LINOTYPE IMPROVEMENT SHEET

NO. 295

AIR COOLED MOLD BLOWER

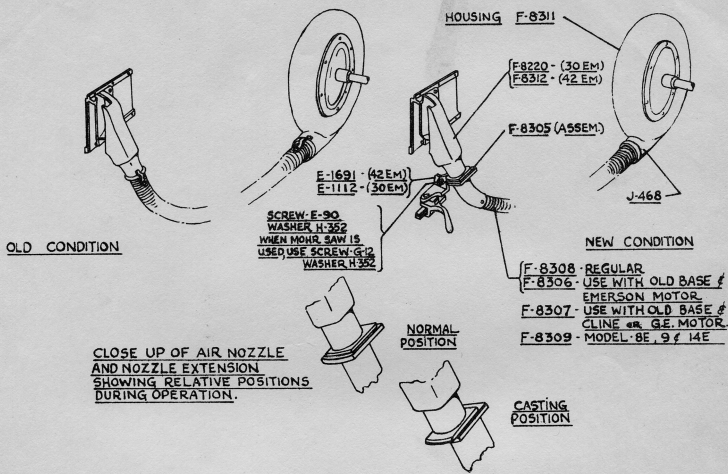
The Air Blower has been redesigned to eliminate disconnecting the Blower Tube when the Mold Disk has been moved out beyond the normal operating position. Rigidity of construction eliminates possible loss of Air and increases efficiency of the system.
